## CSP 25-056 AL BP041 – ADDENDUM No.01 HVAC MEP EAST ZONE 3

Fort Bend Independent School District  
2023 Bond Program

Addendum 01

13 August 2025

R-A2.20

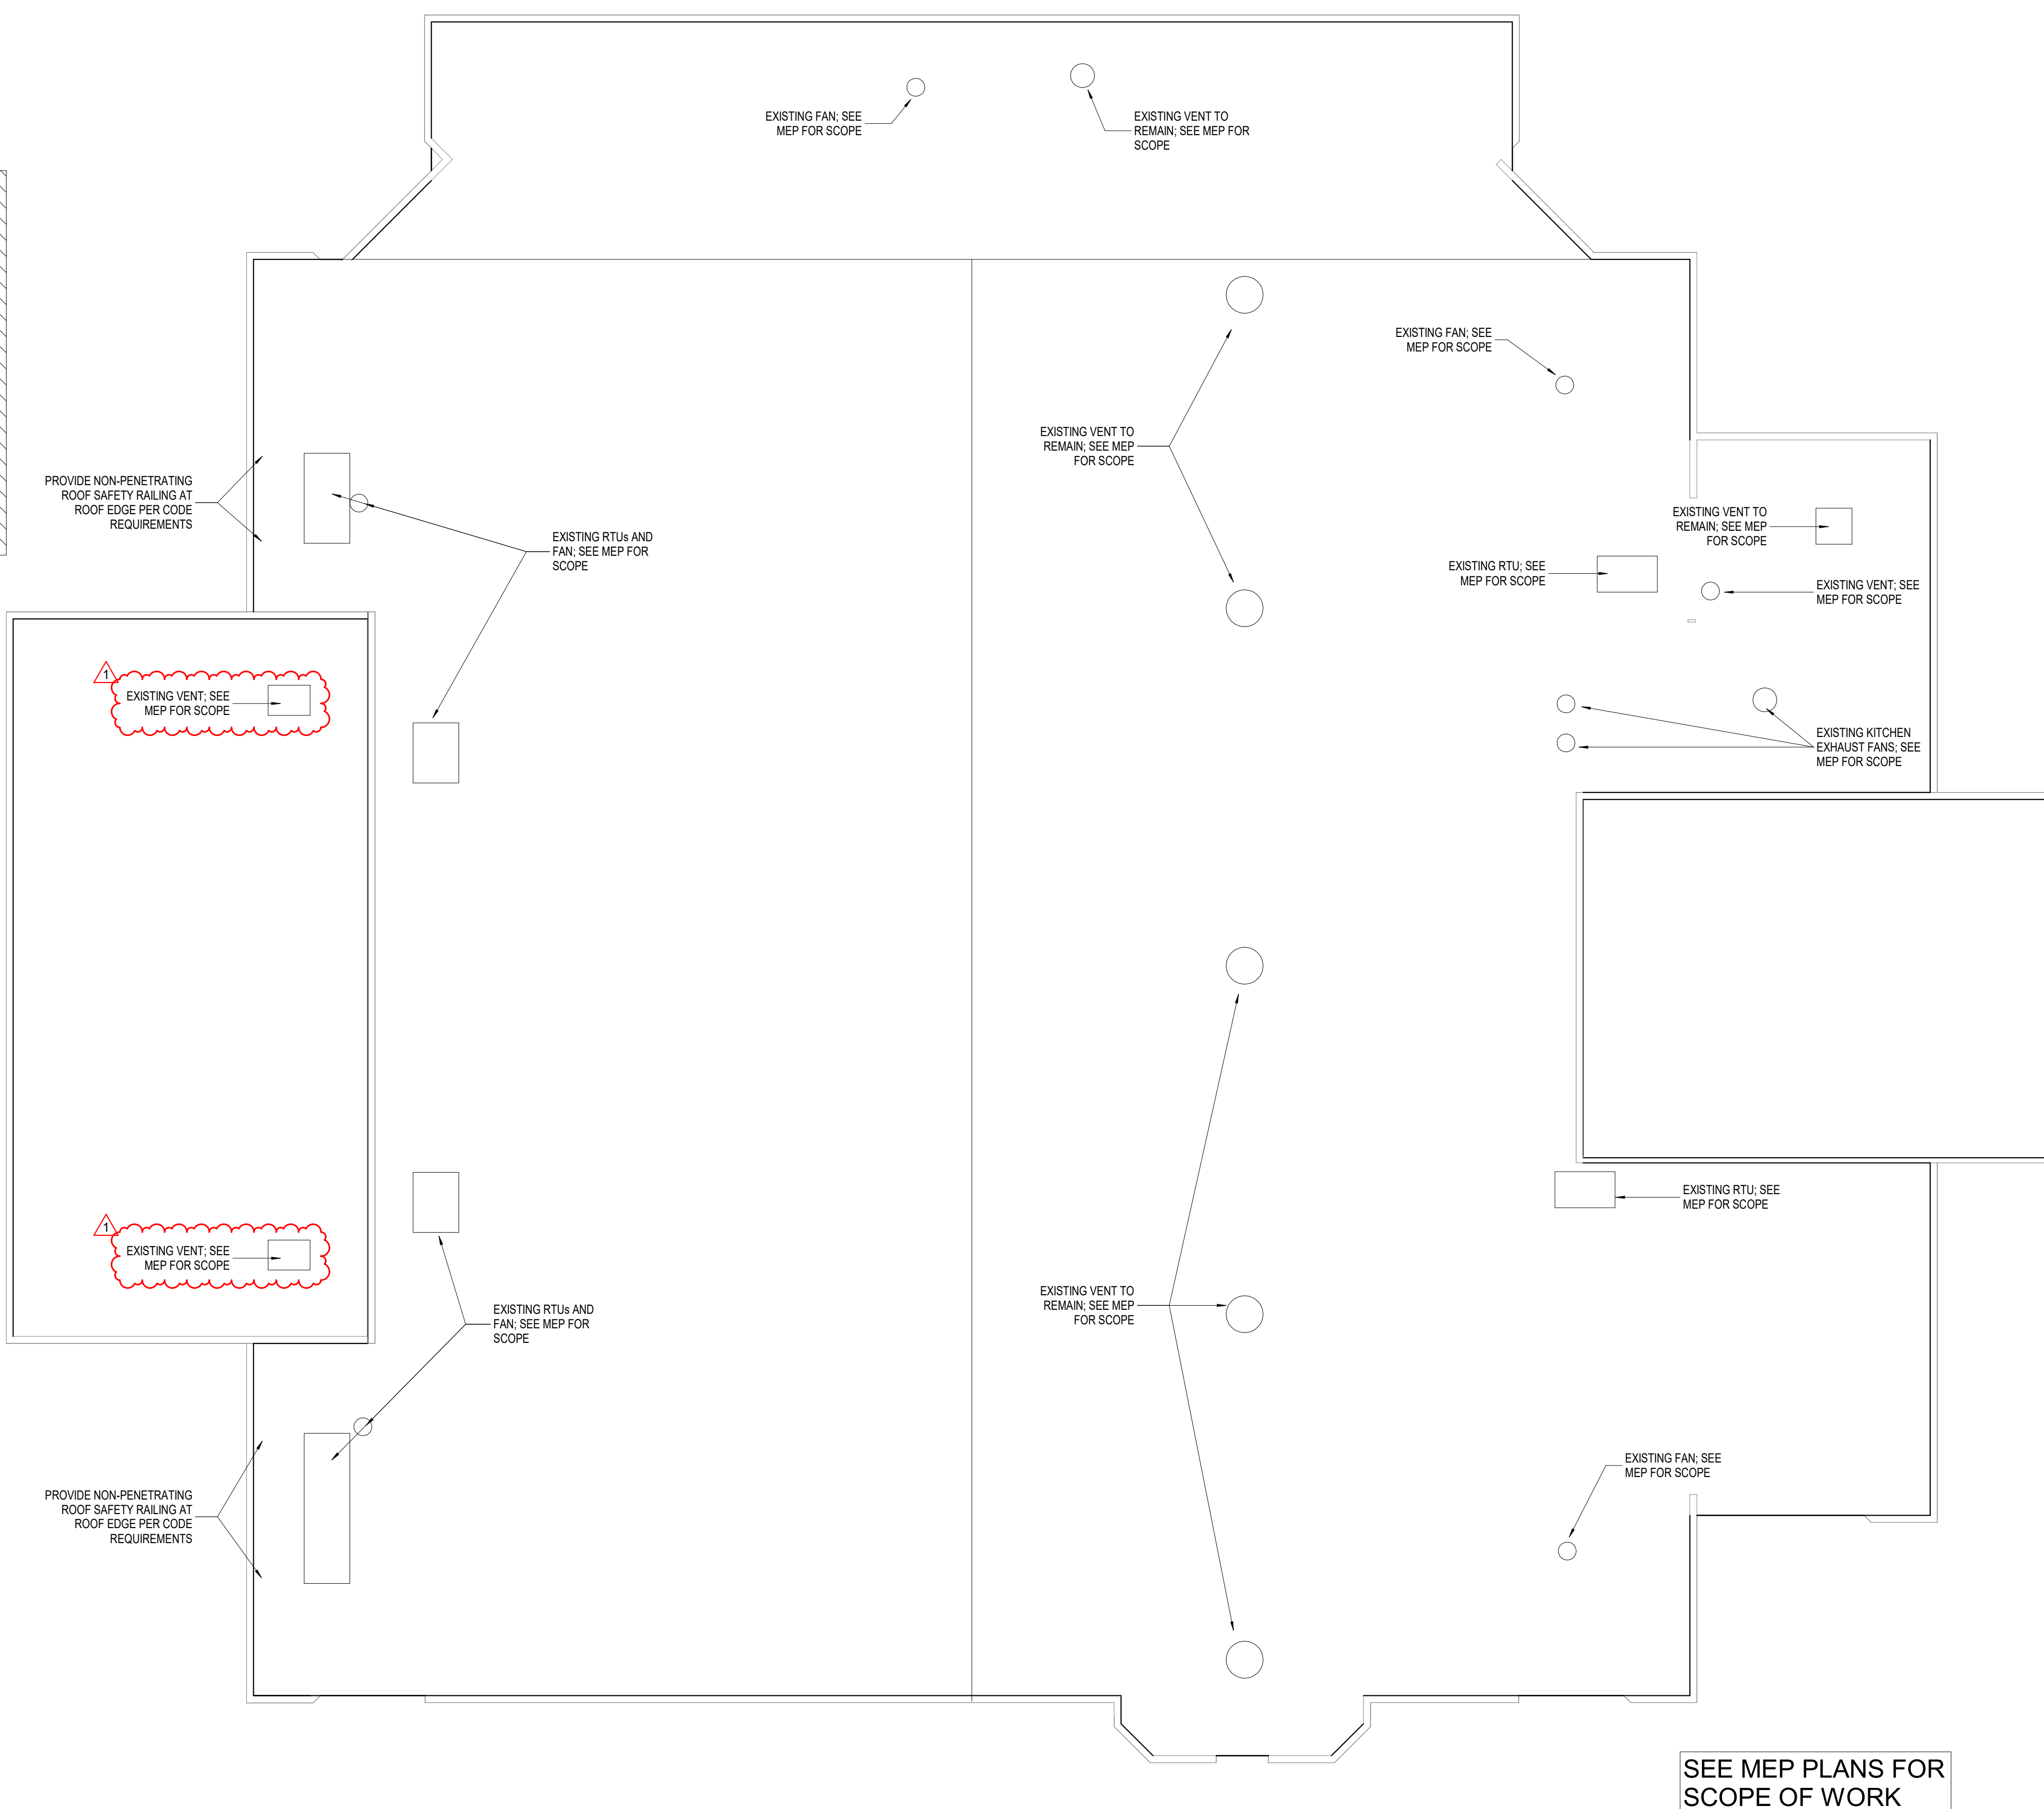
- 01 Sheet R-A2.20 OVERALL ROOF PLAN**
  - a. Existing roof vents to match R-M2.01

R-M2.03

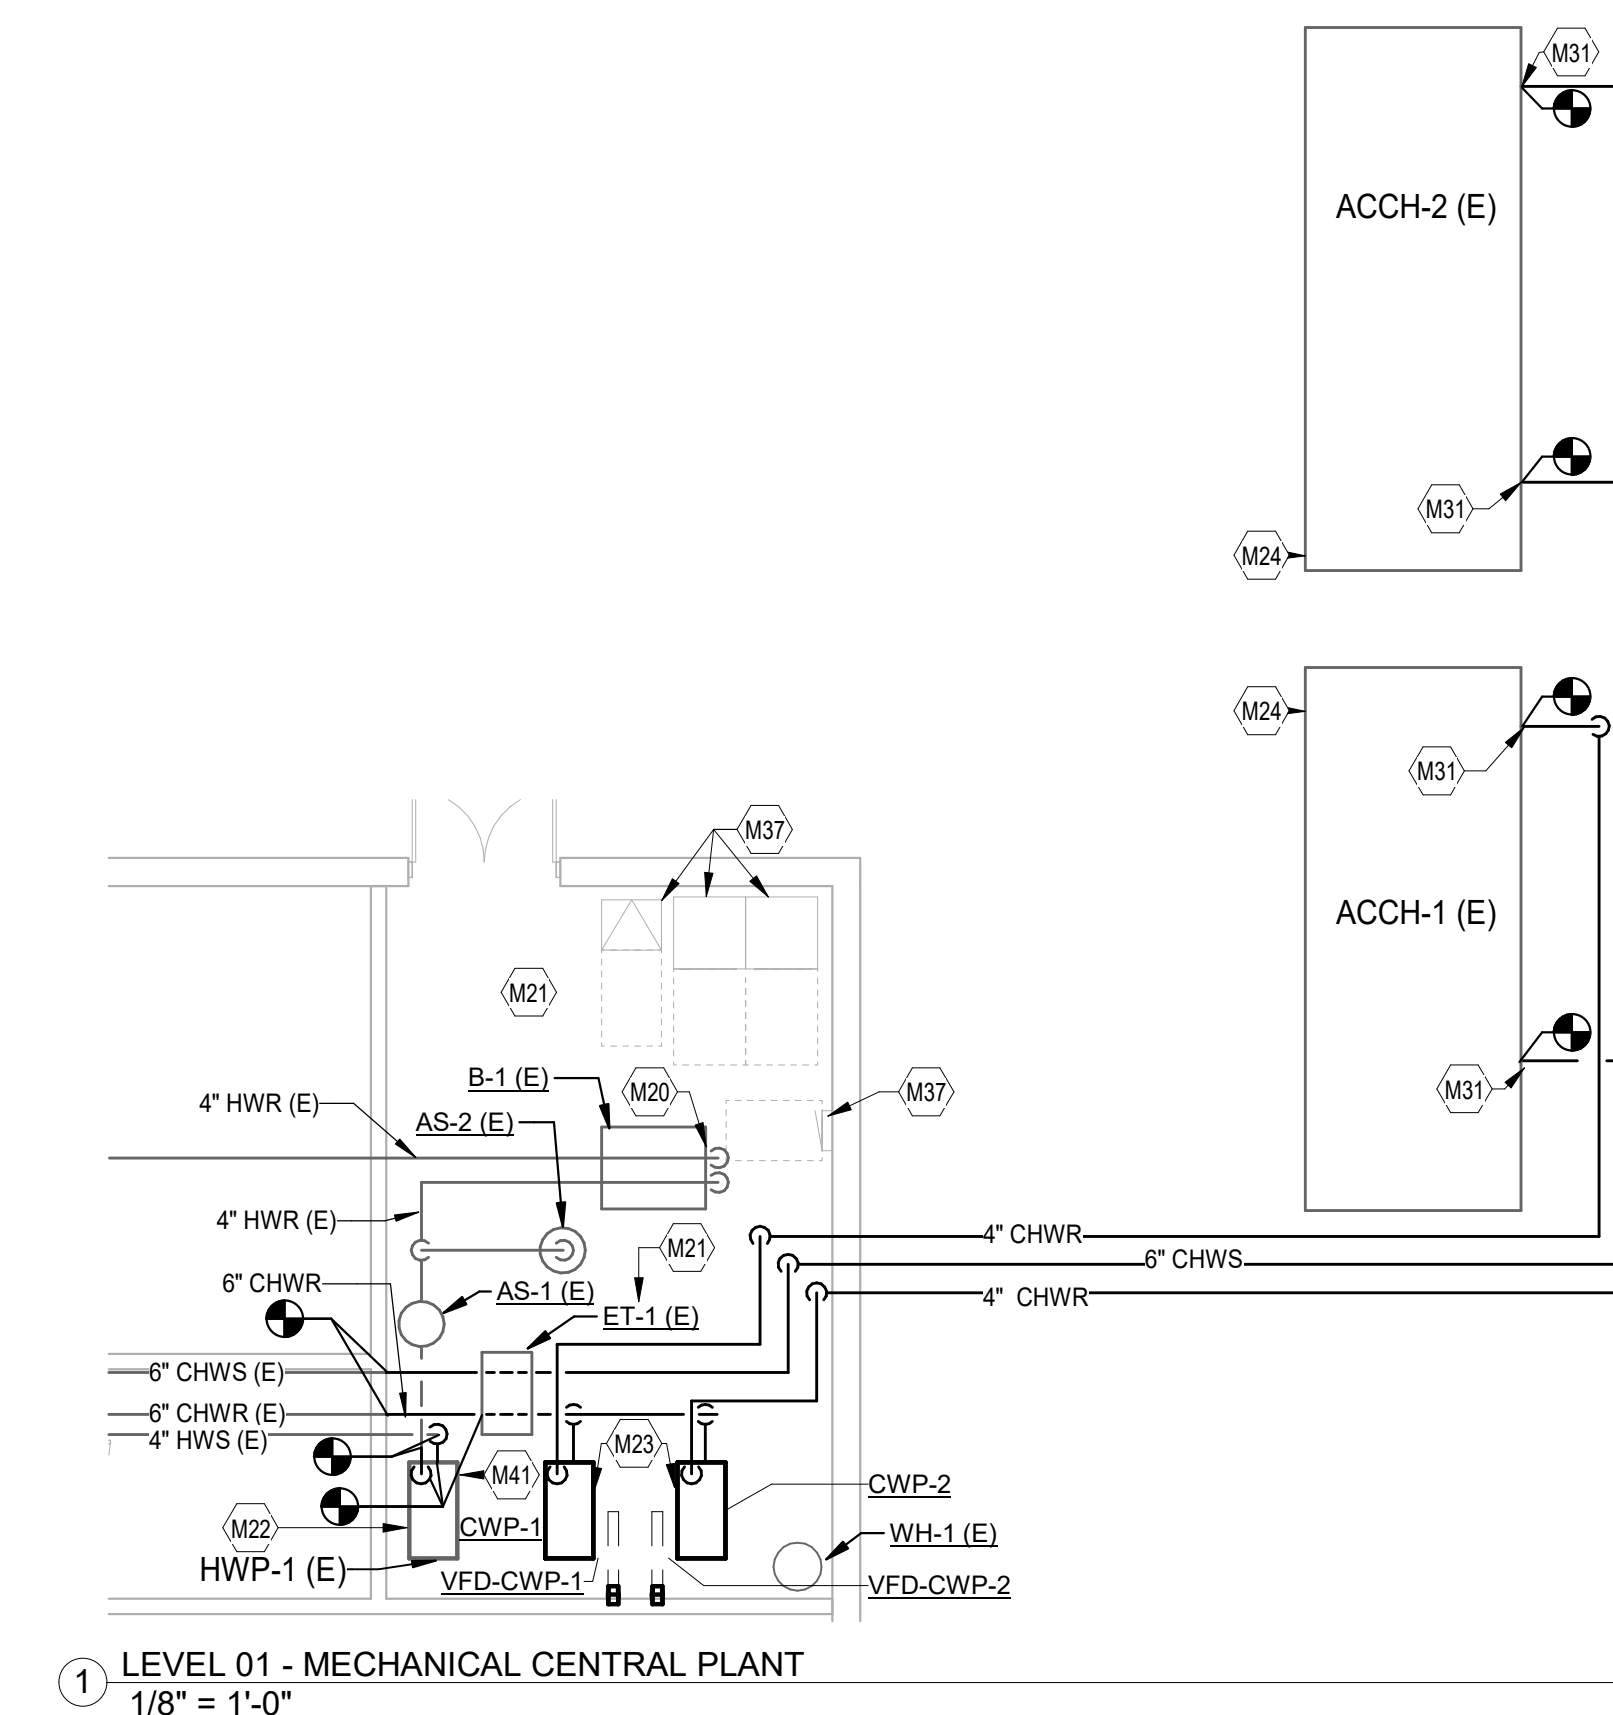
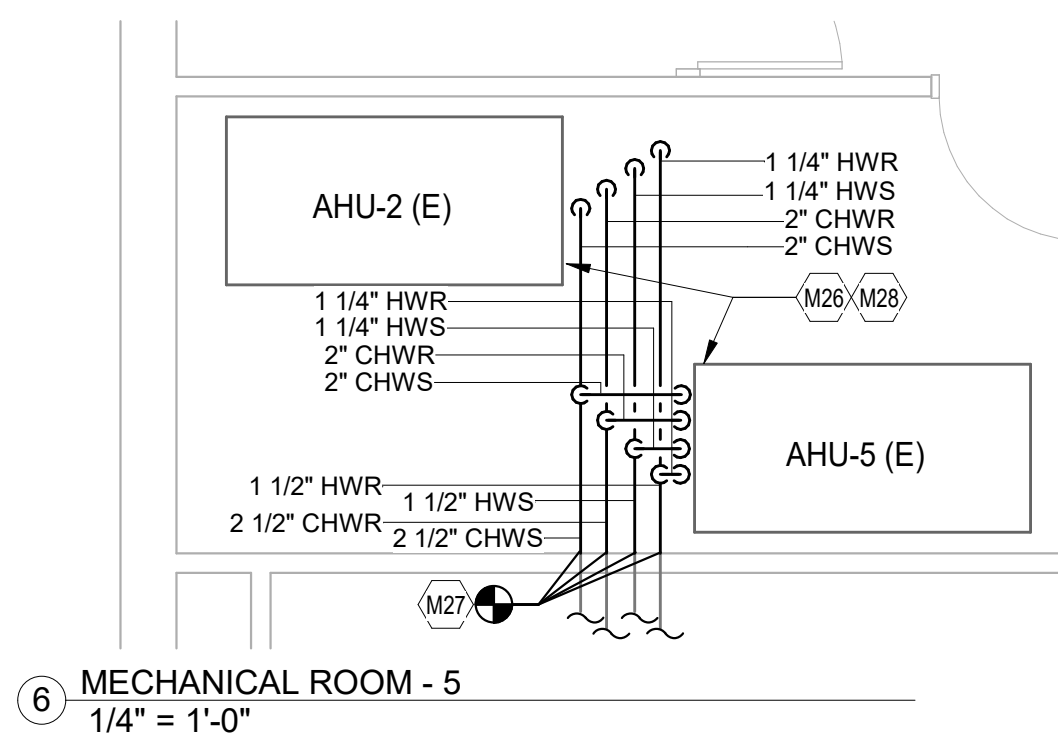
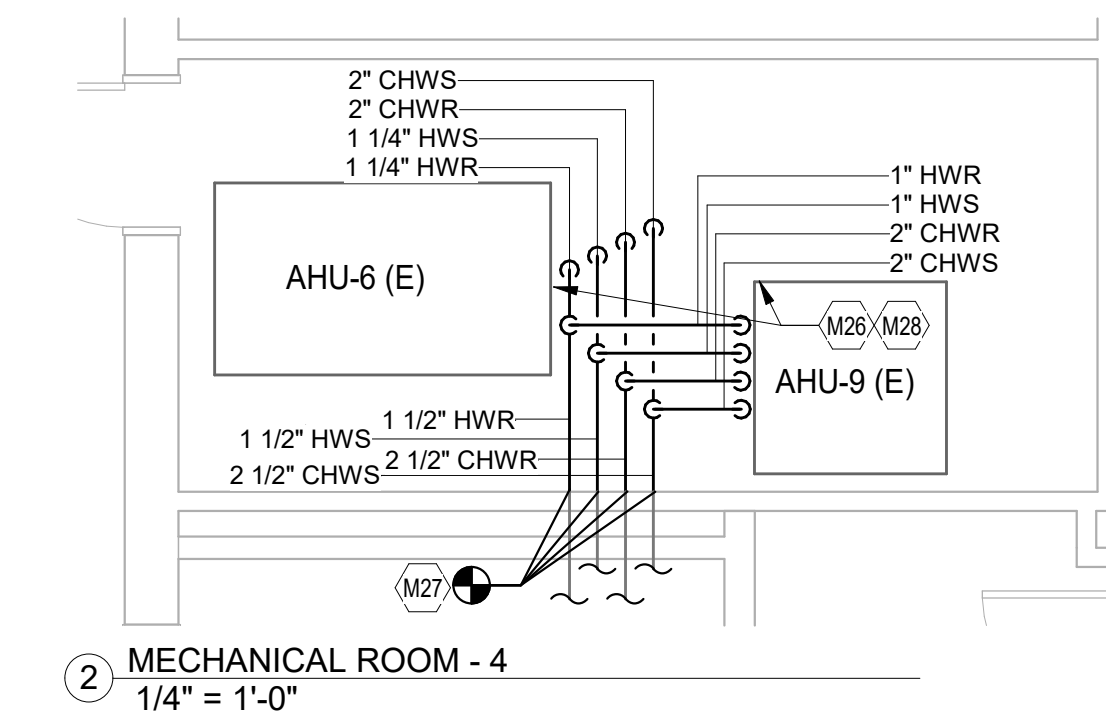
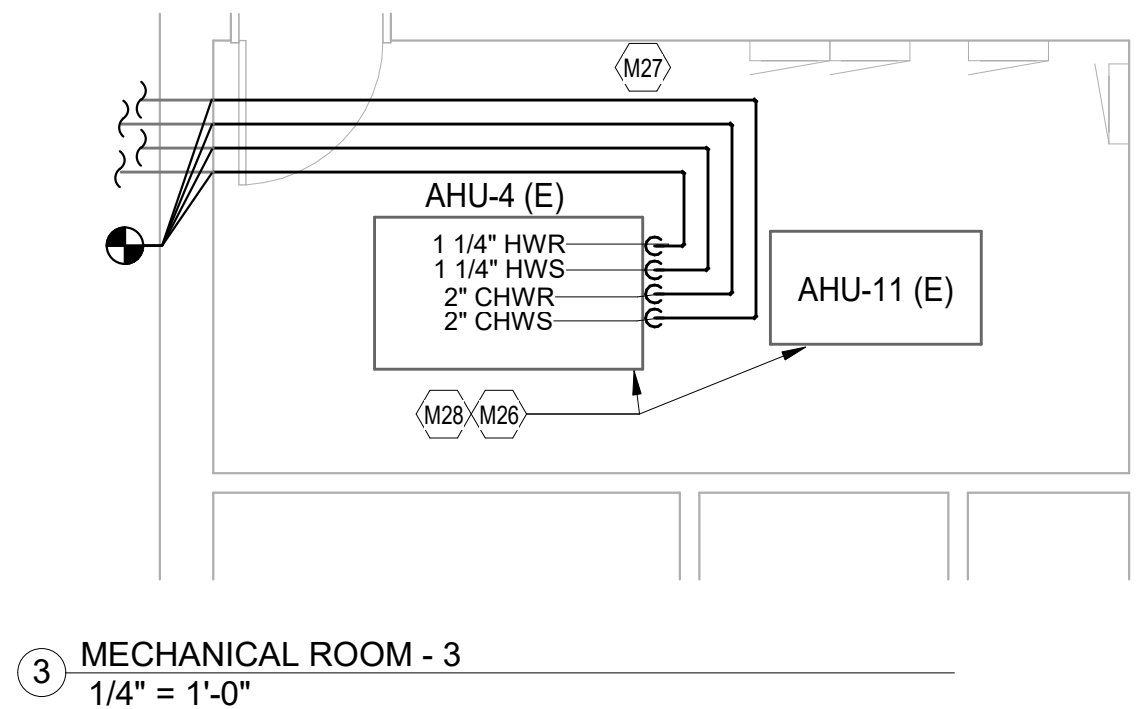
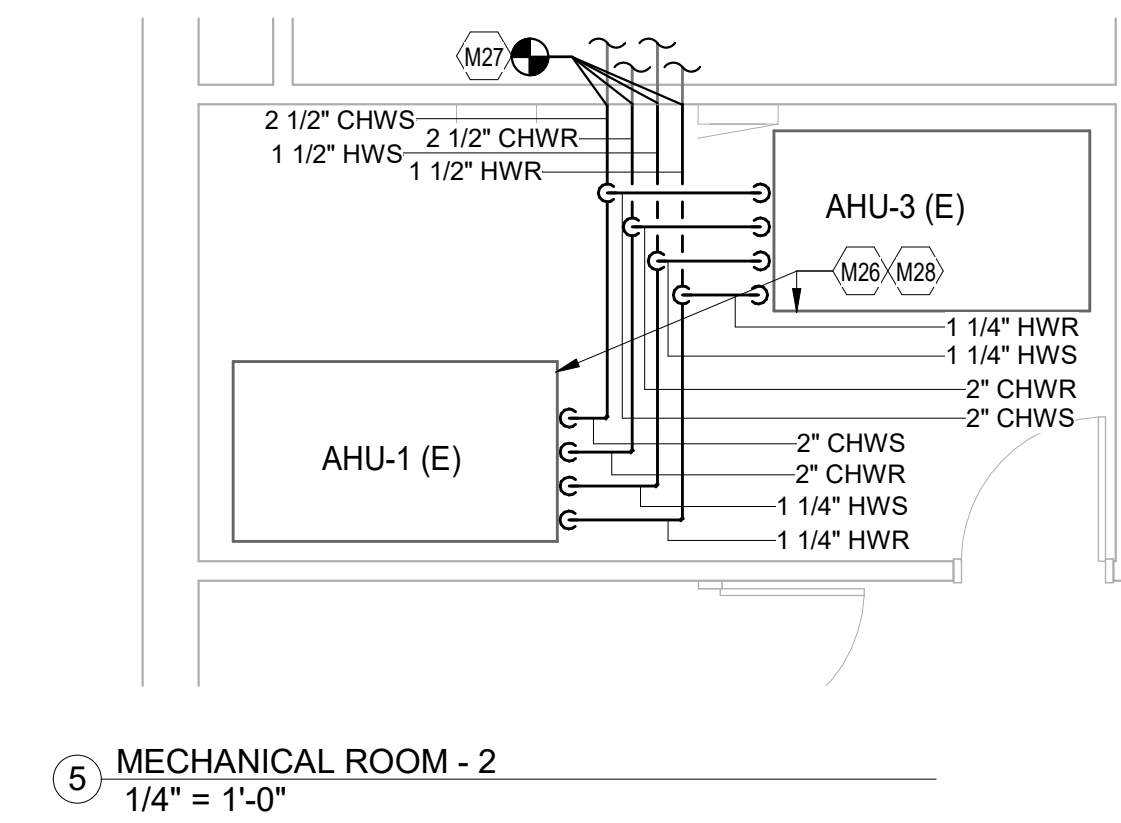
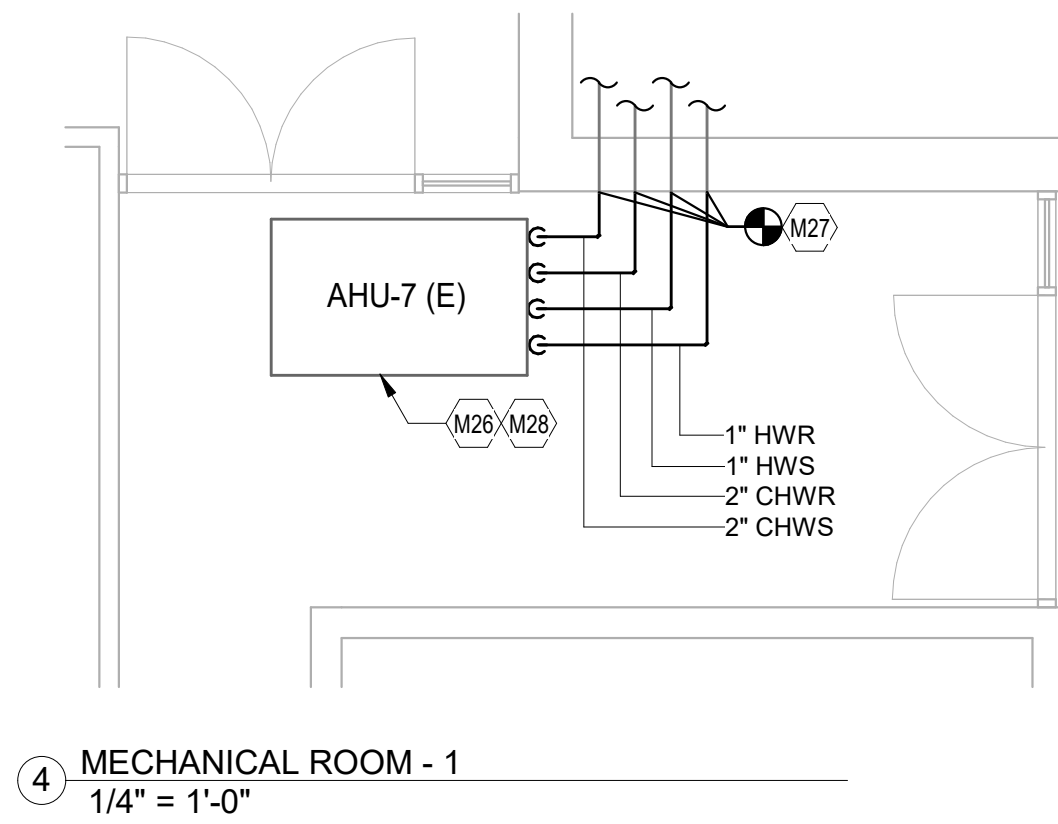
- a. Removed existing roof vents.
- 03 **Sheet R-M2.03 – MECHANICAL ENLARGED PLANS**
  - a. Added keynotes M26, M27, M28, and M36 in Mechanical Room-8.

| M27          | REPLACE EXISTING PIPING IN MECHANICAL ROOMS FROM THIS POINT OUT TO EXISTING AIR HANDLING UNITS. INSTALL NEW ISOLATION VALVES AT THE BRANCH FOR EACH UNIT. EXISTING ISOLATION VALVES AT THE BRANCHES AND MAINS SHALL BE REPLACED. EXISTING CONTROL DEVICES INCLUDING TEMP SENSORS AND CONTROL VALVES SHALL BE REINSTALLED. EXISTING HYDRONIC LAID PIPING IS BACKWARDS. CONTRACTOR TO CONFIRM SUPPLY AND RETURN PIPING FOR RECONNECTING UNIT. |     |
| M28          | EXISTING CONTROL VALVE TO BE REMOVED AND REINSTALLED IN NEW PIPING. CONTROL VALVES ARE A COMBINATION OF 2" AND 3-WAY. REFER TO PIPING SCHEDULE FOR SIZES.   |     |
